SUBJECT: BOARD NOTIFICATION 84-152  
SAFETY EVALUATION REPORT ON TRANSAMERICA DELAVAL, INC.  
(TDI) OWNERS GROUP PROGRAM PLAN; AND SAN ONOFRE  
CRANKSHAFT INDICATIONS

SUBJECT: SAFETY EVALUATION REPORT, TRANSAMERICA DELAVAL, INC.  
DIESEL GENERATOR OWNERS GROUP PROGRAM PLAN

SAFETY EVALUATION REPORT  
TRANSAMERICA DELAVAL, INC.  
DIESEL GENERATOR OWNERS GROUP PROGRAM PLAN

**Review and Evaluation of TDI  
Diesel Generator Owners'  
Group Program Plan**

FIGURE 1. Approach for Establishing Diesel Engine Reliability/Operability

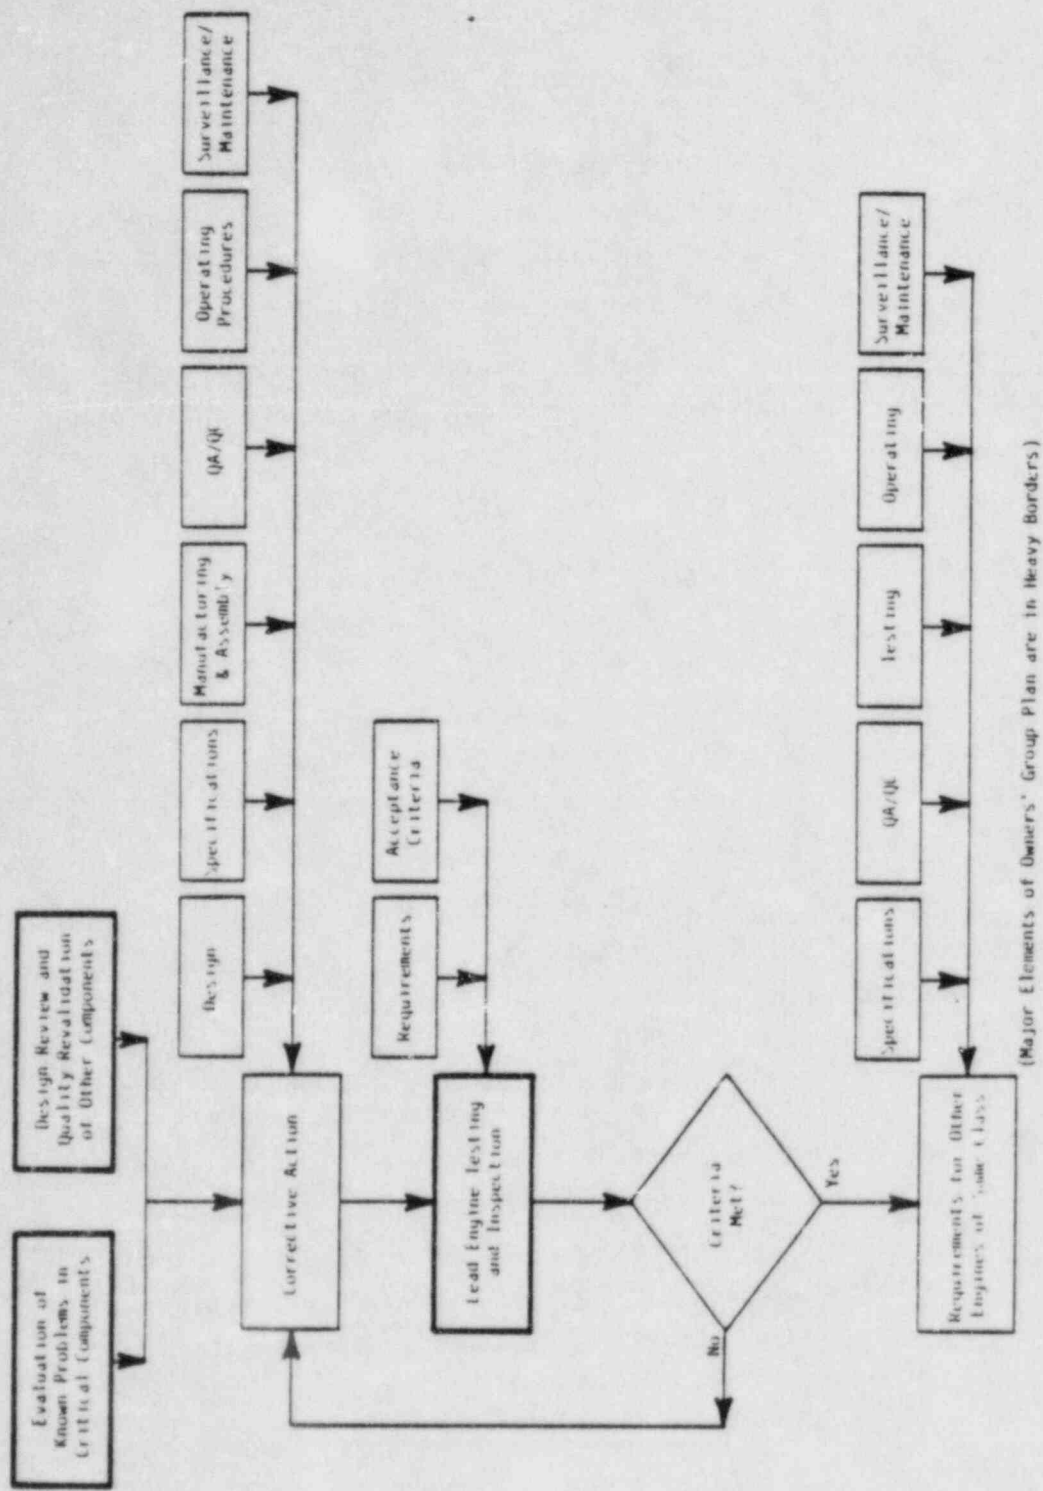
- identification of root cause(s)
- corrective action - As illustrated in Figure 1, factors that should be considered as appropriate include design, specifications, manufacturing and assembly, quality control/quality assurance, operating procedures, and surveillance and maintenance.

The program logic of Figure 1 forms a basis for identifying the critical elements needed to establish TDI engine operability and reliability for nuclear service (i.e., program elements that should be accomplished prior to licensing action). The evaluation of the Owners' Group Plan in Section 2.0 reflects these elements, which are:
